Service Bulletin
No. RSB-E4-024

RECOMMENDED SERVICE BULLETIN

Waste gate – Spring loaded circlip

Engine type: E4
Engine model(s): E4, E4P
Serial number(s): all

Example: Turbo charger for engine configuration "-A" with new spring loaded circlip

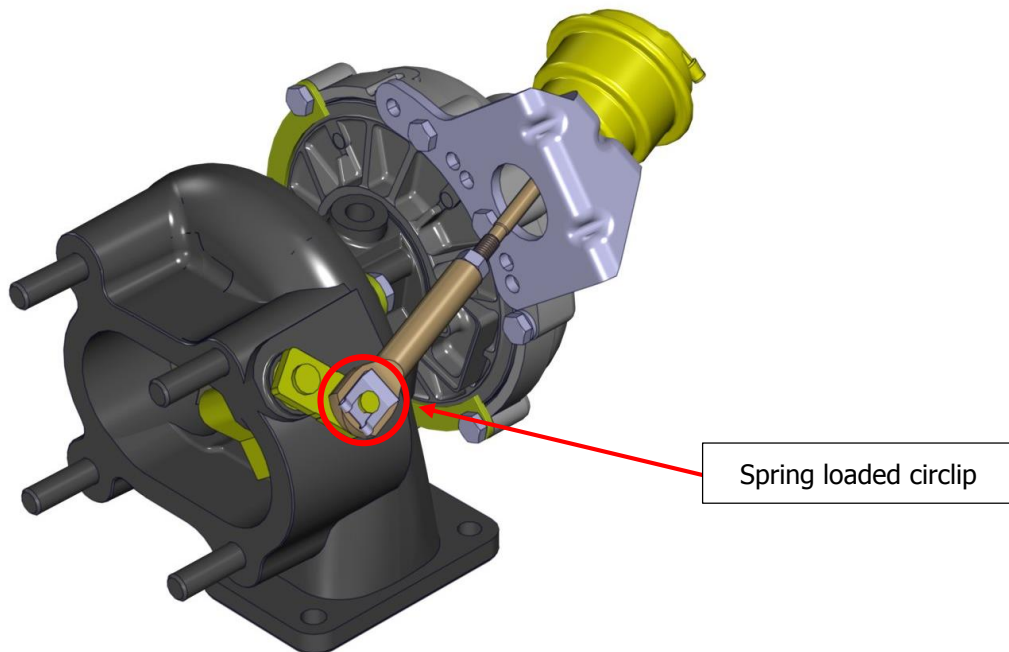
This Service Bulletin describes the replacement of the waste gate circlip, which prevents the waste gate actuator connection rod from disconnecting from the waste gate bolt of the turbo charger. An improved circlip design prevents the incorrect installation of the circlip.

Replace the circlip DIN6799-5 with the spring loaded circlip E4A-41-100-801.
